From: Evans, Michele
Sent: Wednesday, July 09, 2014 10:11 PM
To: Thadani, Mohan; Beasley, Benjamin
Cc: Lund, Louise
Subject: Fw: Comments on draft director's decision on FitzPatrick c nde ser tube petition
Attachments: 20140709-jaf-ucs-nrc-condenser-tube-directors-decision.pdf

**SUBJECT: Comments on Proposed Director's Decision on 10 CFR §2.206
for the James A. FitzPatrick Nuclear Power Plant**

On behalf of the Alliance for a Green Economy, Beyond Nuclear, and the Union of Concerned Scientists, I am responding to the proposed director's decision you transmitted by letter dated June 27, 2014, regarding the petition we submitted on July 25, 2013 pursuant to 10 CFR §2.206. If the 337 days it took the NRC to respond to our safety petition is any indication, we appreciate the careful, deliberate consideration the NRC staff gave to the issues we raised. We also appreciate the compliment about our competence and capabilities you have implicitly conveyed by only giving us 30 days to review and comment on information it took the larger NRC staff nearly eleven times longer to prepare. I re-read our petition to refresh my recollection of the safety issues we had raised a year ago.

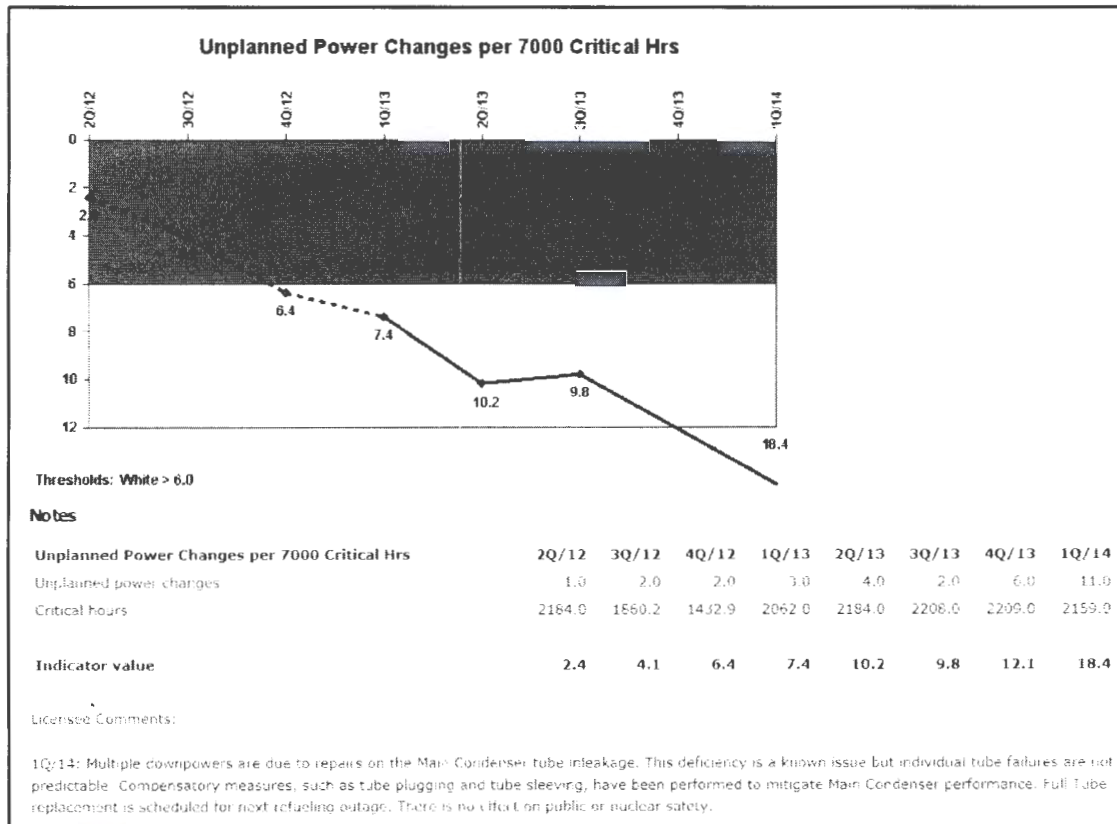
The proposed director's decision states on page 3 that Entergy informed the NRC on January 21, 2013, that the unplanned power change performance indicator crossed the green to white threshold. As shown in this snapshot from the NRC's Reactor Oversight Process webpages, this performance indicator continued to trend downward. In fact, it is now three times worse than the green-to-white threshold of six unplanned power changes per 7,000 critical hours. It has literally dropped off the chart. When the NRC developed this chart back in 2000, the agency did not contemplate any reactor experiencing more than 12 unplanned power changes per 7,000 critical hours. Yet FitzPatrick reached 18.4 unplanned power changes per 7,000 critical hours by the first quarter of 2014.

Thus, FitzPatrick's performance has literally dropped off the charts—far, far below that ever envisioned by the NRC staff in designing this safety measure.
